# International Aero Engines INFORMATION BULLETIN

ENGINE - INFORMATION - PROVIDE NEW FRONT AND REAR NO. 4 BEARING FACE SEALS

V2500-ENG-70-0801

Family Tree - Seal Assembly, No. 4 Bearing, Front  
Ref. Catalog Sequence No 72-42-33. Fig. 01 Item 010  
Figure 1

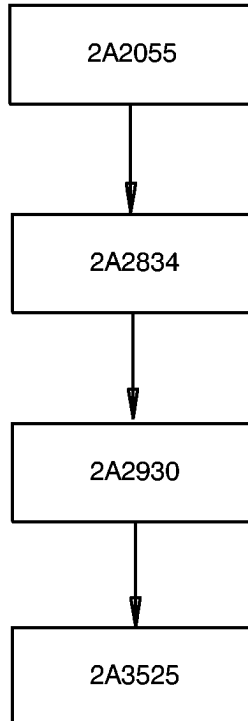
V2500-ENG-70-0801 ENGINE  
- INFORMATION - PROVIDE NEW  
FRONT AND REAR NO. 4 BEARING  
FACE SEALS

Family Tree - Seal Assembly, No. 4 Bearing, Rear  
Ref. Catalog Sequence No 72-43-20. Fig. 01 Item 020  
Figure 2

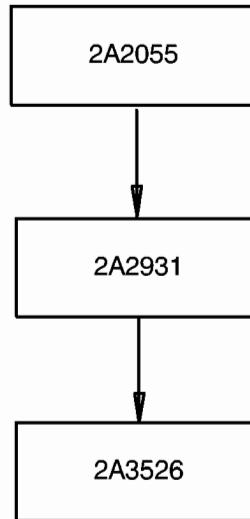
V2500-ENG-70-0801  
ENGINE - INFORMATION -  
PROVIDE NEW FRONT AND REAR  
NO. 4 BEARING FACE SEALS
